**Lopez NO COALition Comment**  
**on the proposed**  
**Kinder Morgan Trans Mountain Pipeline Expansion Project**

Fig. 1. Map showing results of computer simulations of how a large oil spill at the Tsawwassen ferry crossing (location D) would have spread during the summer of 2012 (see reference 19).

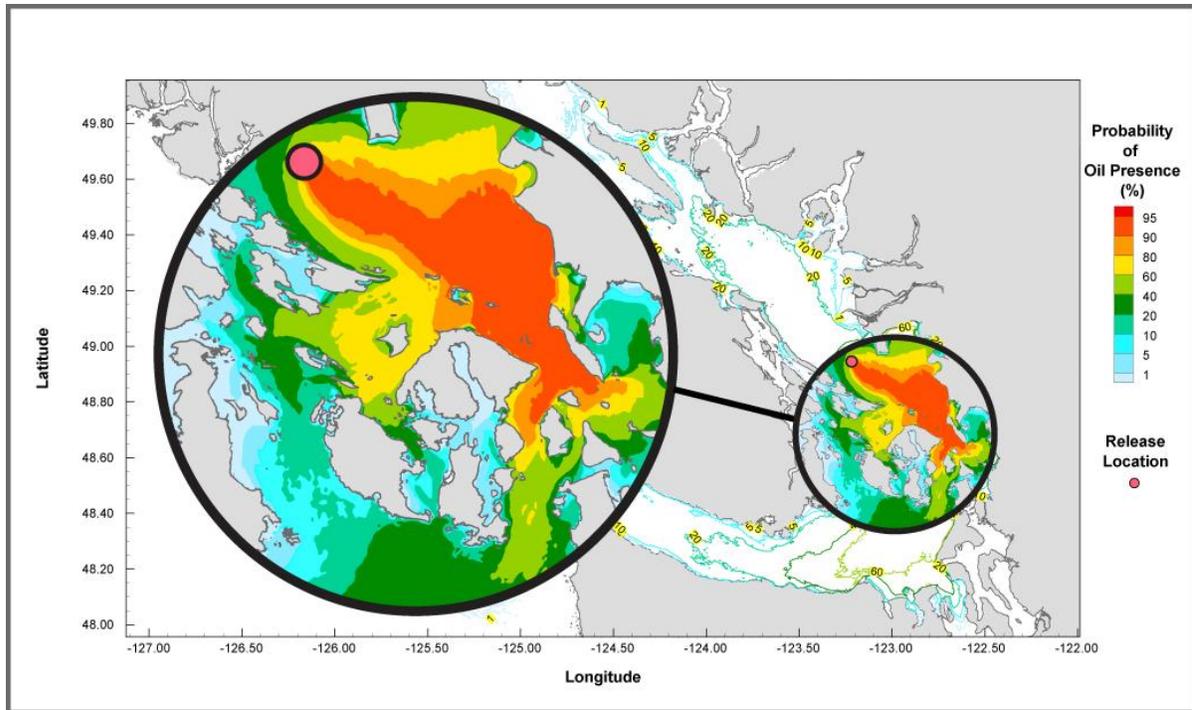
In the summer, for example, the combination of strong Fraser outflows, northwest winds in Georgia Strait, and tidal exchanges would usually push a spill southeastward toward Rosario Strait, most severely impacting Orcas Island and Whatcom County shorelines and to a lesser extent Blakely and Decatur Islands and the National Monument shorelines on Lopez Island (see Fig. 1). Without containment, within the first 24 hours, oil would reach Patos and Sucia

Fig. 2. The average time that will elapse before oil from a spill at location D would reach the shores of the San Juan Islands, Gulf Islands, Saanich Peninsula and Whatcom County, based on simulations of a large oil spill that could have occurred during the summer of 2012.<sup>15</sup>

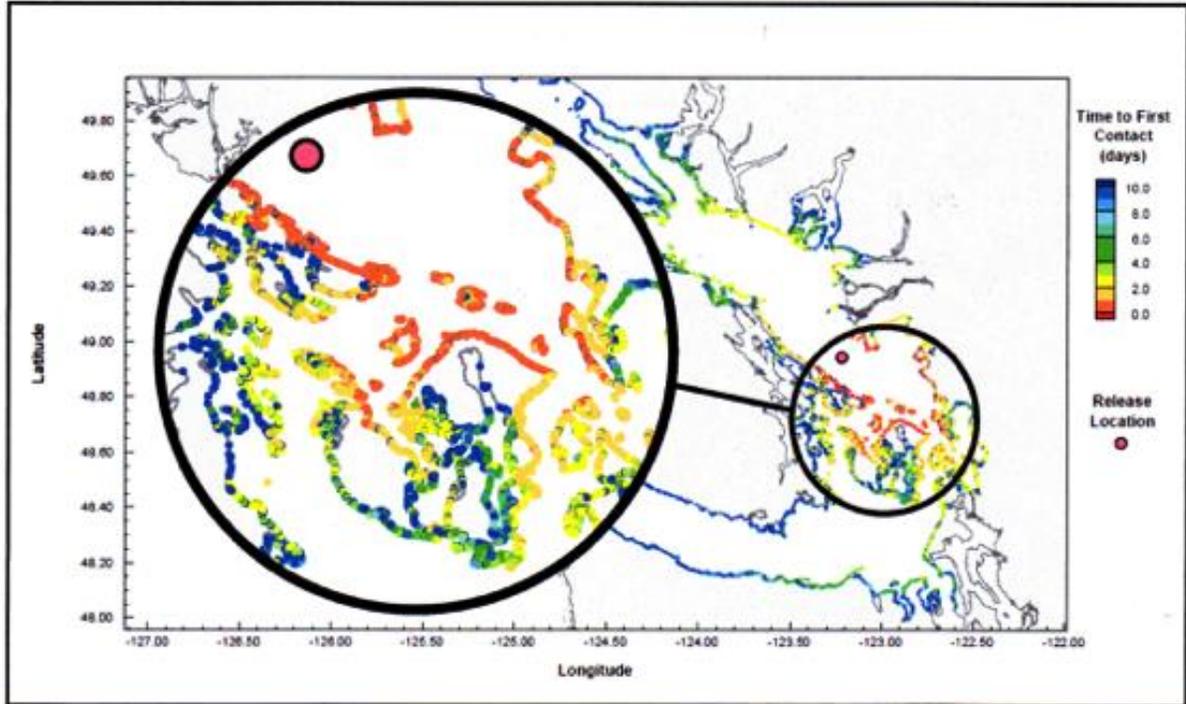
Islands and the north shore of Orcas (see Fig. 2). The shores of Lummi Island and the sensitive Cherry Point Aquatic Reserve would begin experiencing impacts after a similarly brief period of 1-2 days.
